Applicant Response to Staff Report

The March 2023 HDC meeting addressed design changes to the rear elevation of the Dr. Sweet House.

Following Commission approval, COA 23-8237 was issued on 3/15/2023:

West Village Example- Proposed Sample 5

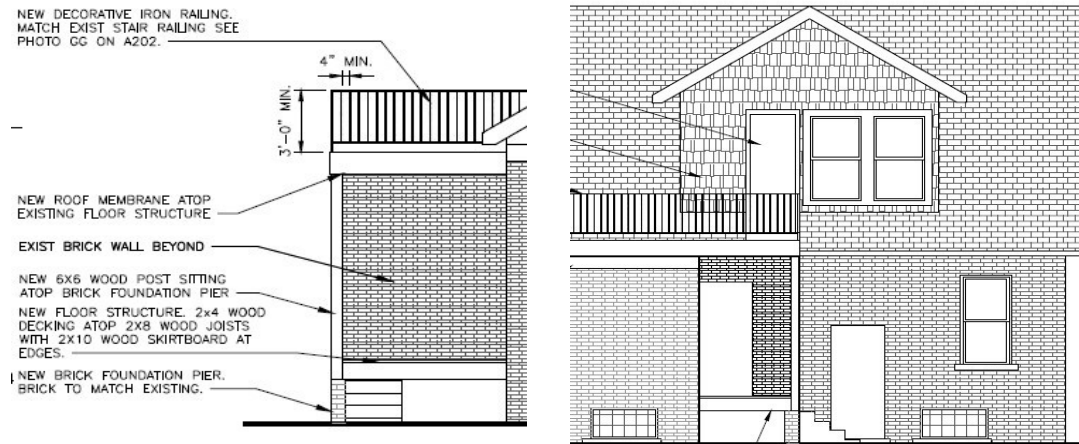
A total of 7 perimeter railing designs were proposed in conference with the HDC (1 on 4/13/23 and 6 on 8/2/23). This HDC proposal is based on the recommendation from the 8/2/23 call. All alternatives proposed to Staff, based on actual houses in East and West Village, are illustrated below.
